Proposal for the 01 series of amendments to Regulation No. 86 (Installation of lighting and light-signalling devices for agricultural vehicles)

Submitted by the Working Party on Lighting and Light-Signalling*

01 series of amendments to Regulation No. 86 (Installation of lighting and light-signalling devices for agricultural vehicles)

Examples of arrangements of approval marks

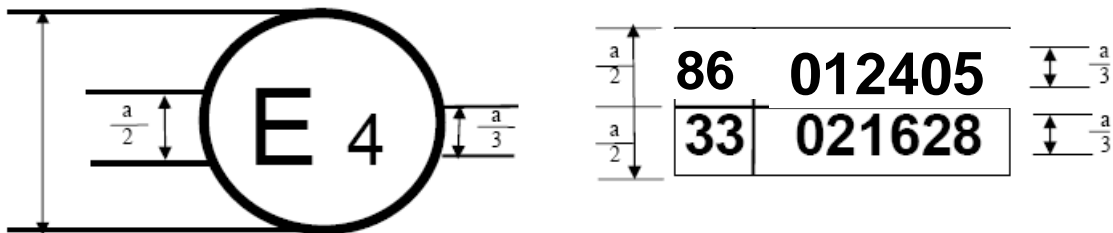
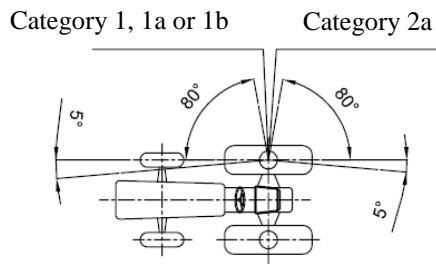
Annex 2, amend to read:

The above approval mark affixed to an agricultural or forestry vehicle shows that the vehicle type concerned has, with regard to the installation of lighting and light-signalling devices, been approved in the Netherlands (E 4) pursuant to Regulation No. 86. The approval number indicates that the approval was granted in accordance with the requirements of Regulation No. 86 as amended by the 01 series of amendments.

The above approval mark affixed to an agricultural or forestry vehicle shows that the vehicle type concerned has been approved in the Netherlands (E 4) pursuant to Regulations Nos. 86 and 33*. The approval numbers indicate that, at the dates when the respective approvals were given, Regulation No. 86 was as amended by the 01 series of amendments and Regulation No. 33 already included the 02 series of amendments."

Direction-indicator lamps - Geometric visibility

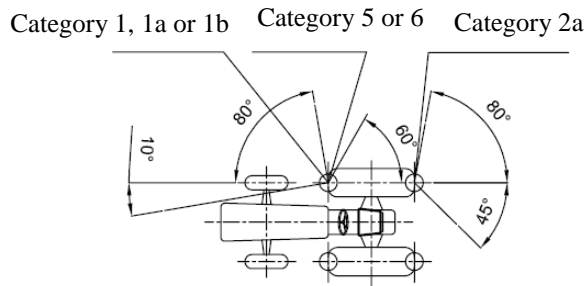
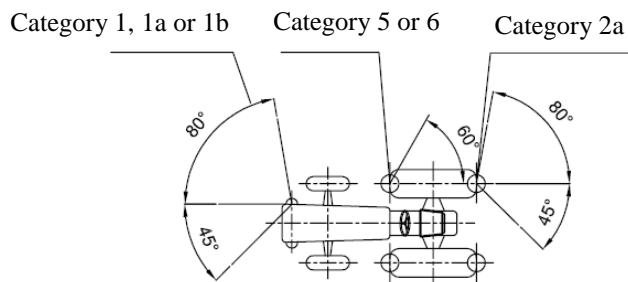
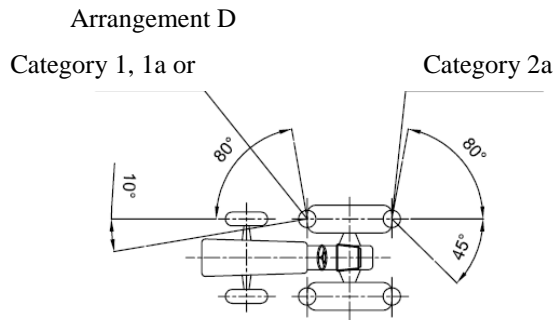
Annex 5, amend to read:

For all the arrangements the following applies:

The value 10° given for the inward angle of visibility of the front indicator may be reduced to 3° for vehicles with an overall width not exceeding 1,400 mm.

For rear direction indicators, the horizontal inward angle may be reduced to 30° if the shape of the bodywork makes it impossible to reach 45°."

Figure 1.

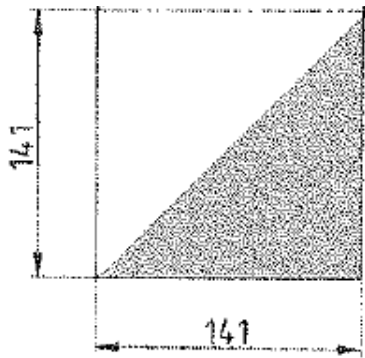
Insert a new Annex 6, to read:

- 1. Dimensions, arrangement, number and minimum reflecting surface
- 1.1. Signalling panels and signalling foils shall have the following dimensions:

Figure 2.

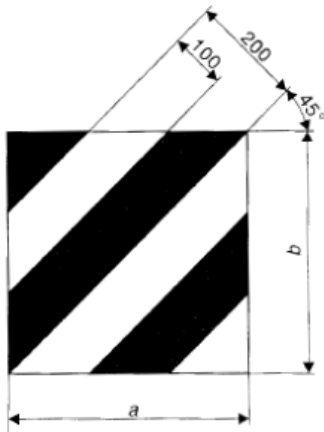
Deviations from the specified formats are permitted, provided that:

- (a) The visible surface of each panel or foil shall be at least equal to 4 basic standard areas and
- (b) Each panel or foil shall comprise at least 3 entire basic standard areas.

If the structure, design or the operational use of the vehicle makes it impossible to comply with such a requirement, each panel or foil may be split into 2 parts as long as each part comprises at least 2 entire basic standard areas.
